# **A G E N D A**

## **Architectural Review Board**

**December 19, 2018**

668 Ponce de Leon

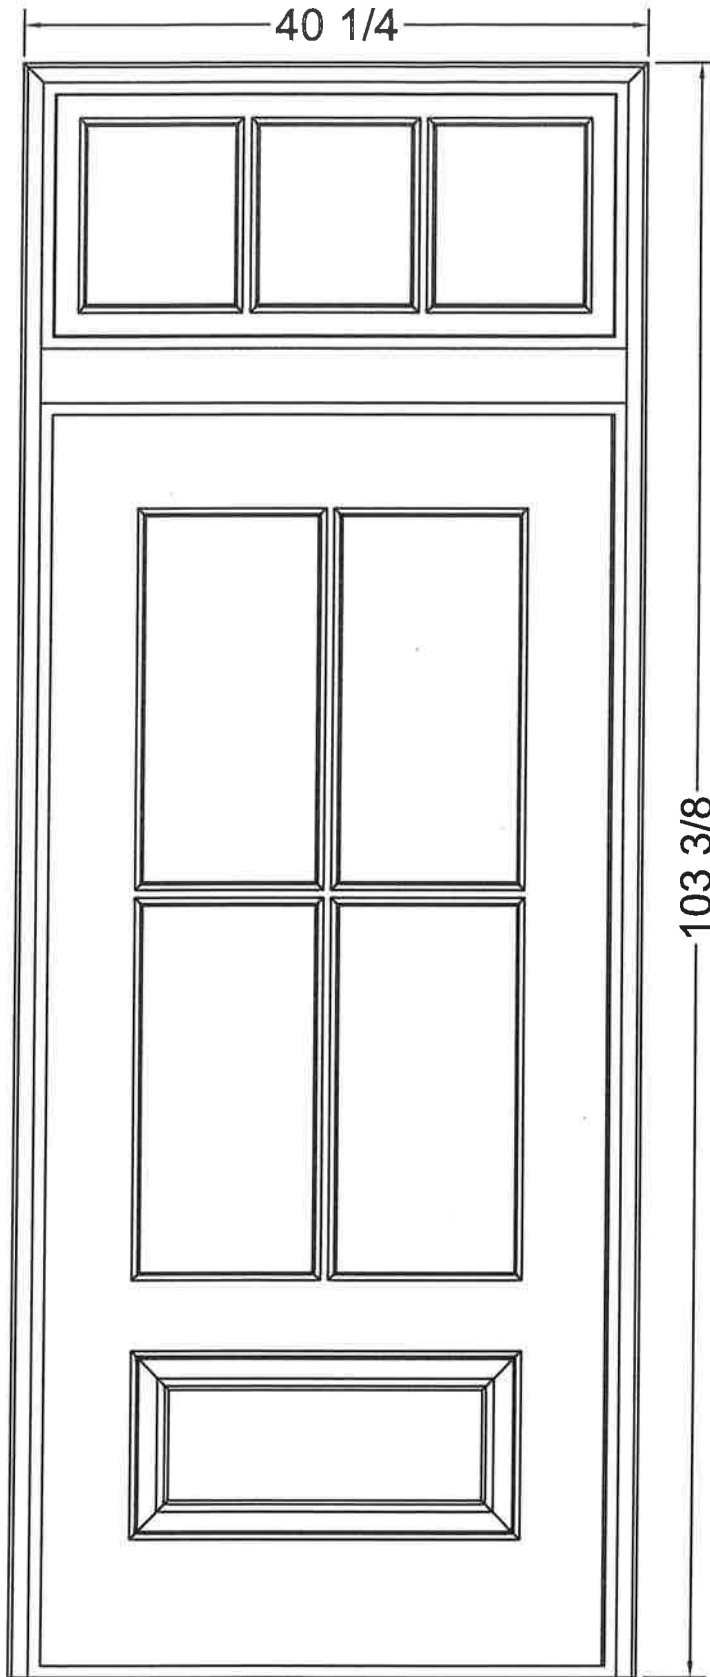
- A 4 lite door is not a typical configuration for the style of house but has been approved in some instances (and also installed without approval in some districts).

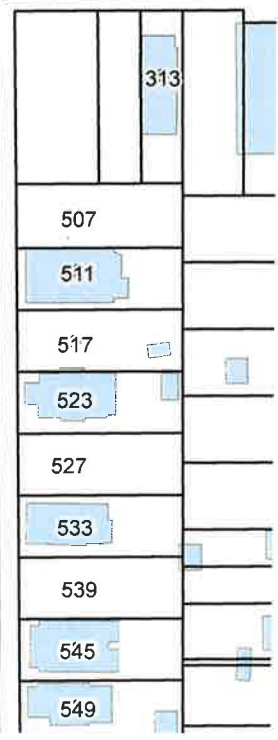
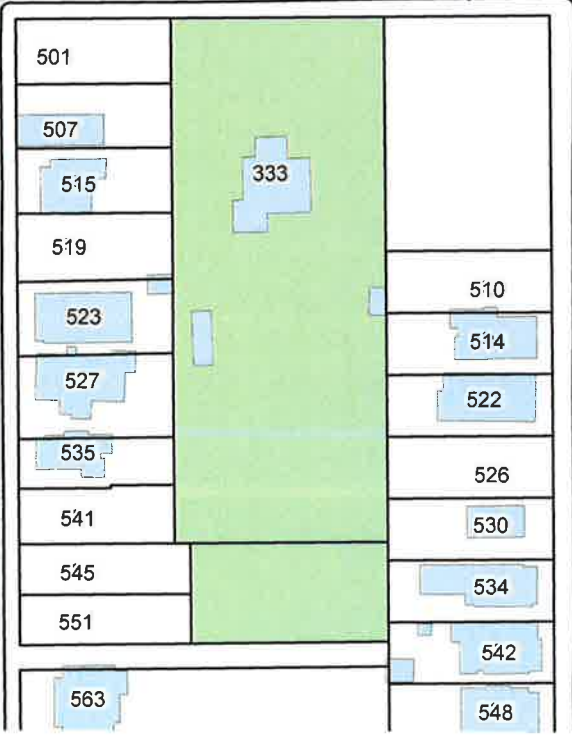
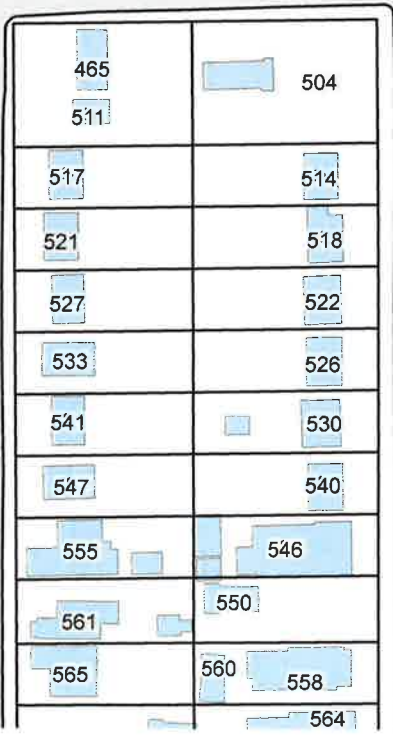
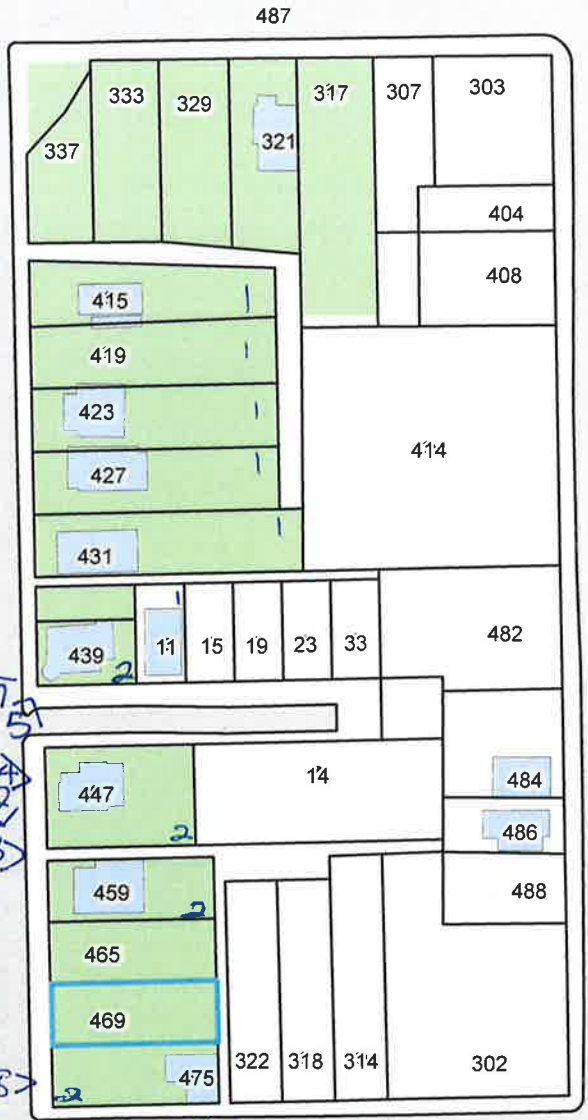
- As shown on the Sanborn map, there was a two and a half story house on this lot in approximately the same location.
- The clump of trees is comprised of 2 water oaks, a hackberry, and multiple cherry laurels. Urban Forester recommends a replacement of at least one oak tree at the SE corner of the lots after construction is completed.
- Plans were not reduced and are in the packet separately.
